2019-05-14

**REQUEST FOR PROPOSAL
RFP #02 (2019-04)
CONSULTING SERVICES
FOR FRONT ENTRANCE AND WELCOME AREA
ADDENDUM # 4**

EXTENT OF WELCOME AREA

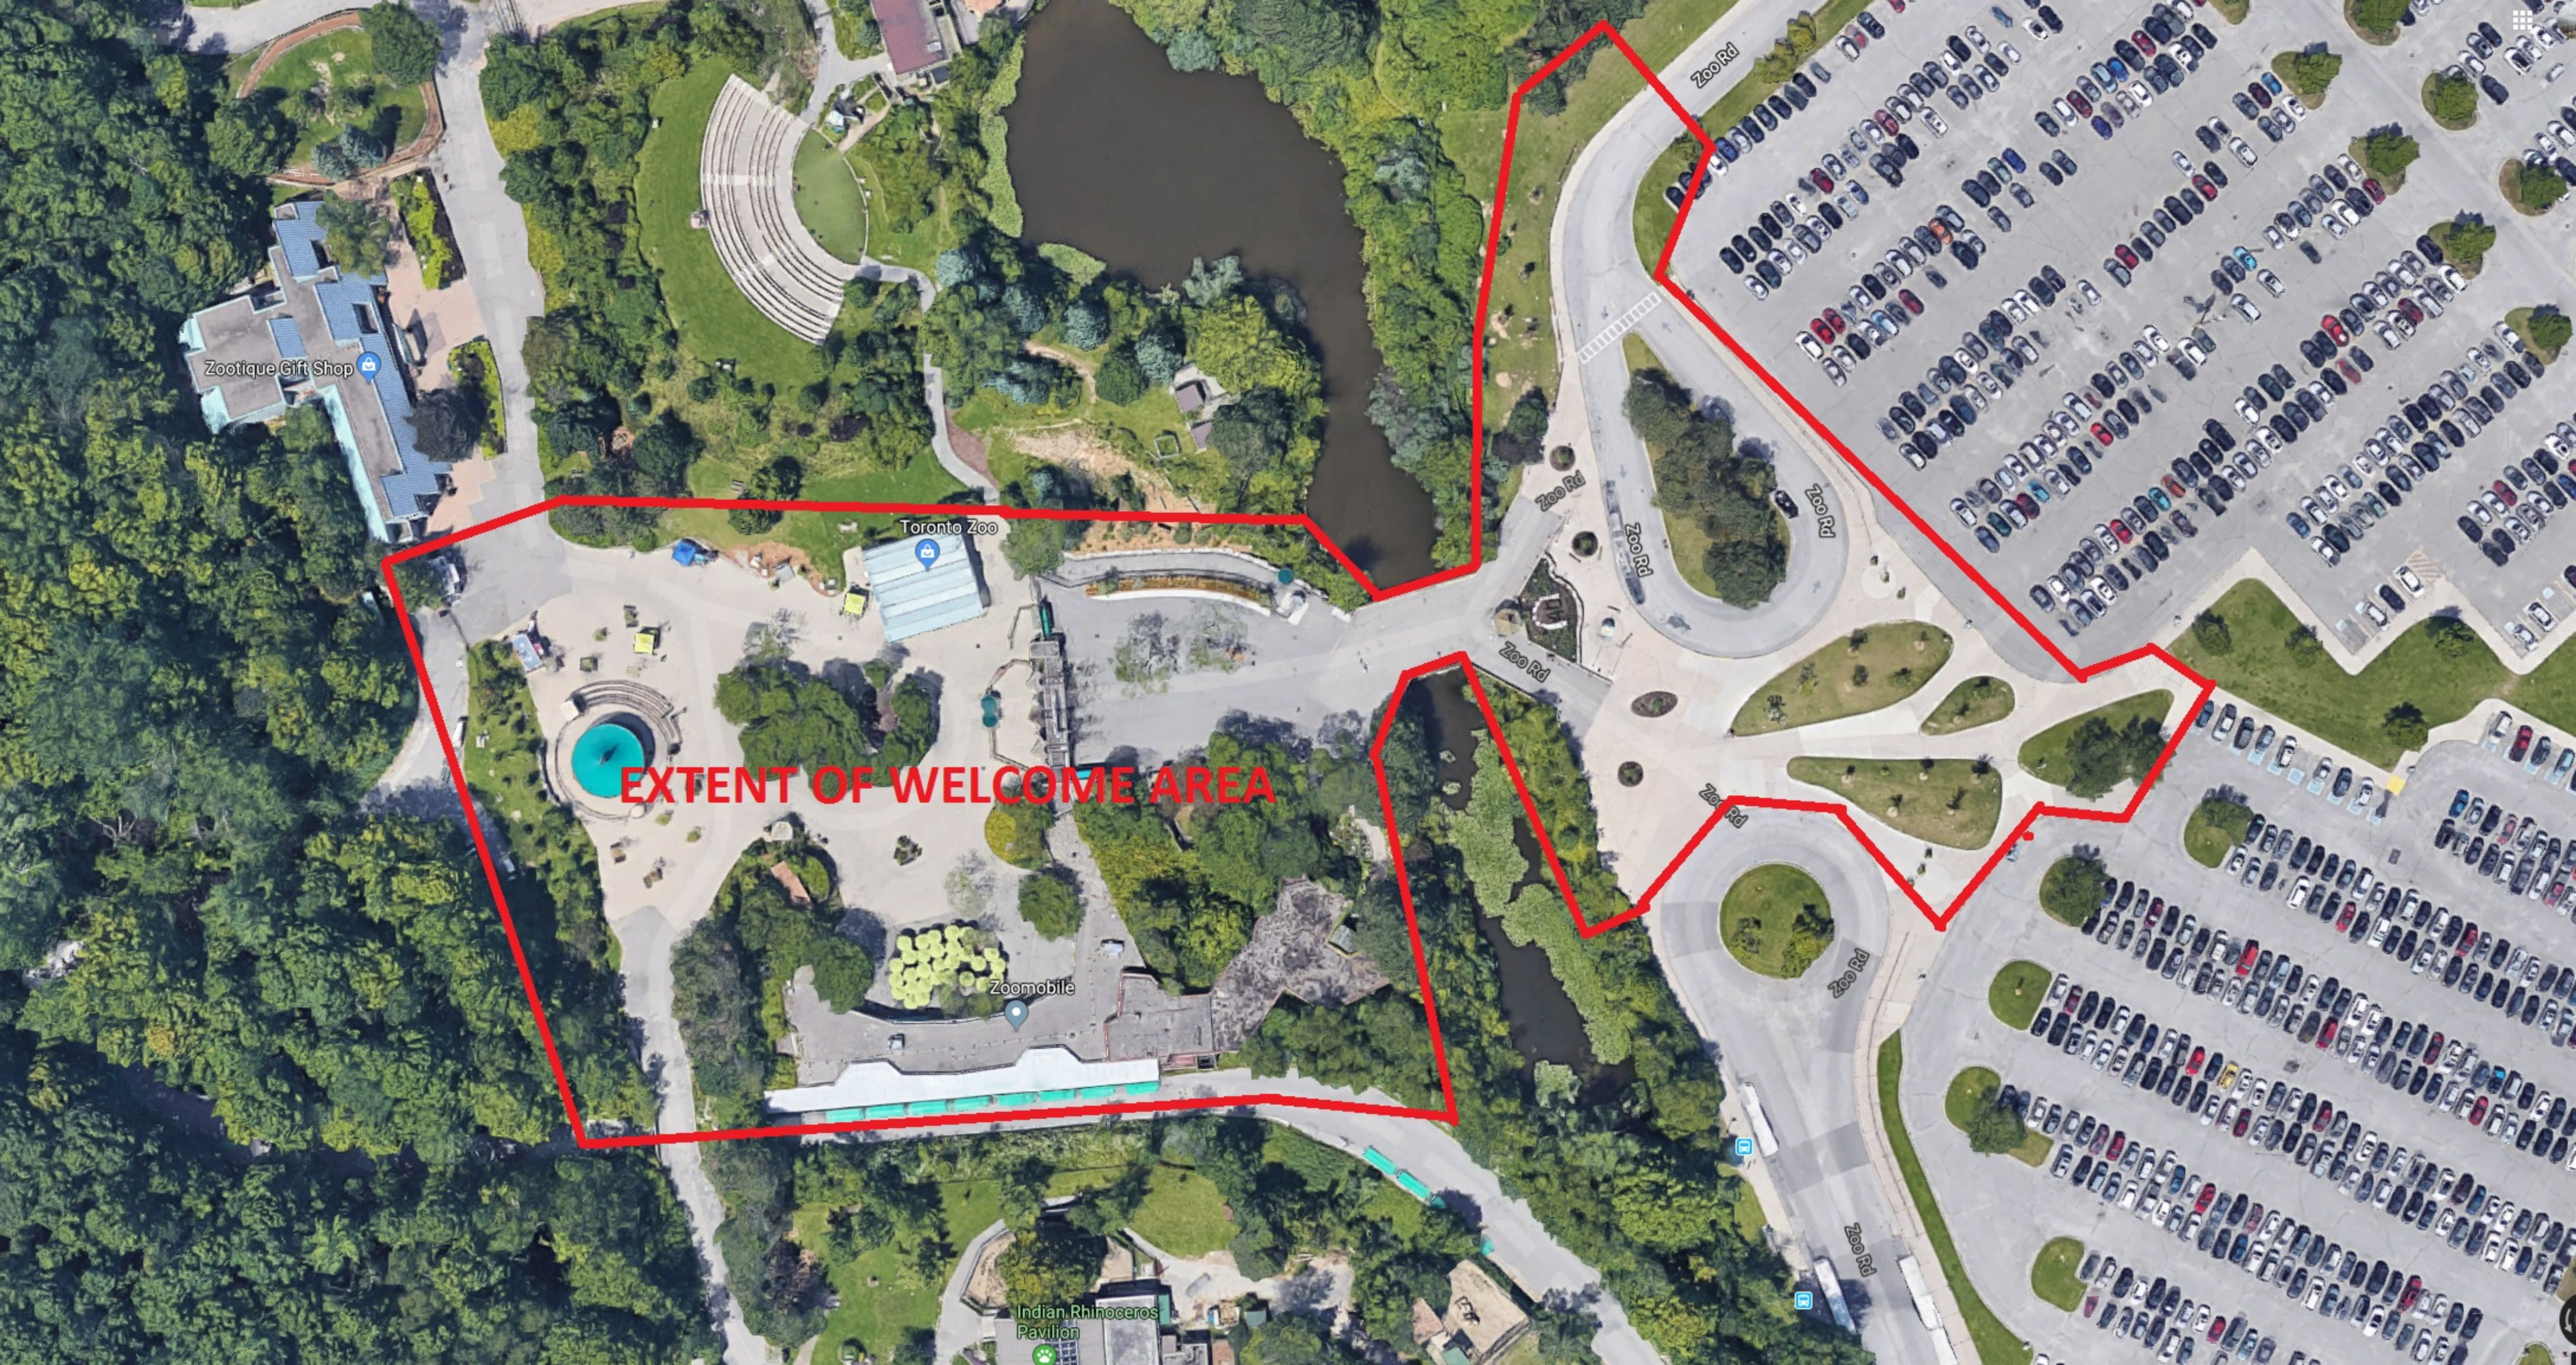
1. **QUESTION:** Could the Zoo confirm the total square footage of the landscaping?

ANSWER: The total square footage of the landscape will be determined by the design. The total area of scope of work is approximately 18,000 m² (see attached plan for extent of work).
